Planning Application No. A/NE-TK/870

Table A: Responses to Departmental Comments

Proposed Temporary Place of Recreation,Sports or Culture (Hobby Farm) with Ancillary Facilities and Associated land filling for a Period of 3 Years at Various Lots in D.D. 17, Ting Kok, Tai Po, N.T.

STORMWATER DRAINAGE PROPOSAL

Layout Plan

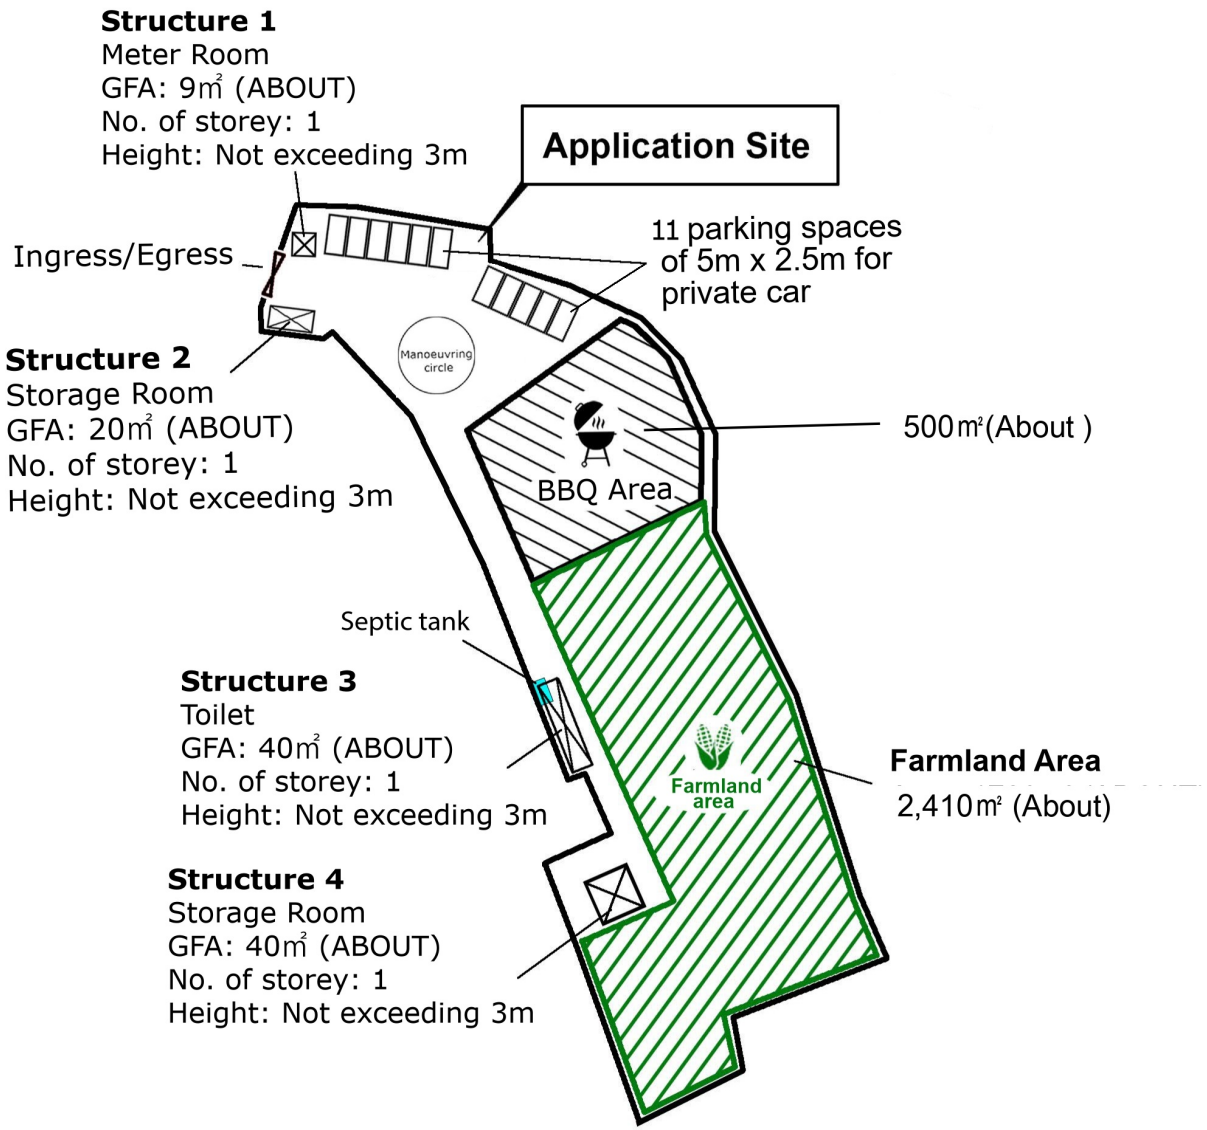
Departmental Comments	Responses
	Transport Department (Contact: Mr. Issac CHAN; Tel: 2399 2406)	
(a)	We note that the proposed temporary place of recreation, sports or culture (hobby farm) with ancillary barbecue site will accommodate up to 4 staffs and 40 visitors at one time. Since there are vacant spaces within the site, the applicant may consider to provide additional parking spaces to meet the operation need.	申請人已重新審視場地佈局，為了充分滿足訪客及員工的營運需求，並嚴格避免車輛在汀角路一帶進行路邊停泊，申請人利用場內的空置空間，增設幾個私家車停車位， 申請人已修改 Layout Plan，增加停車位，以滿足營運需求，避免停車位不足的問題。 申請人承諾在營運高峰期（如週末及公眾假期）實施嚴格的人流及交通管制措施，確保進入場地的車輛數目不超過場內所設的停車容量，以維持周邊交通暢順。 請看附件 1：Revised Layout Plan

STORMWATER DRAINAGE PLAN (SCALE 1:600)

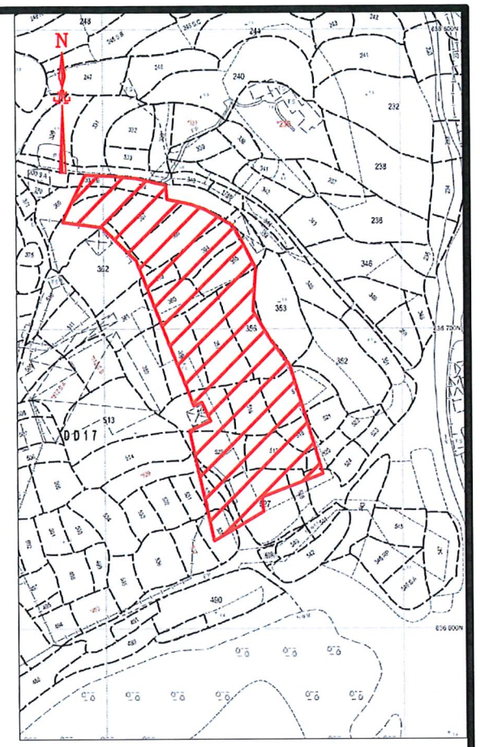
Departmental Comments	Responses
	Drainage Services Department (Contact: Ms. Karen HO; Tel: 3960 8930)	
(a)	I have reservation on the subject application as there is landfilling works to be carried out at the application site which may cause adverse drainage impact to the surrounding lands and premises. As such, the applicant is required to provide further information to demonstrate that the development will not cause adverse drainage impact to the adjacent areas.	申請人已做好排水建議書。 請看附件 2：Drainage Proposal

A 450 mm precast concrete U-channel will be constructed along the perimeter of the Application Site, except along the portion of the site currently used and retained as Farm land, as indicated in green on the proposed drainage plan.

Catchpits shall be installed at each change in alignment of the U-channel to facilitate the unobstructed conveyance of stormwater and to permit routine inspection and maintenance throughout the operational life of the temporary development.

The proposed U-channel shall be laid at a minimum longitudinal gradient of 1:100, in full compliance with the prevailing design standards stipulated by the Drainage Services Department for open channel drainage works.

A catchpit incorporating a sand trap (designated CP-8 on the layout plan) is proposed at the final discharge point before connecting it into the existing u channels of the Application Site, immediately upstream of the connection to the existing downstream drainage system. This provision is intended to prevent the discharge of sand or waste into the receiving watercourse and ultimately into the marine environment.

All stormwater collected within the Application Site via the proposed U-channel and catchpits shall be conveyed by gravity flow to Existing CP-2. From CP-2, the collected flow shall be
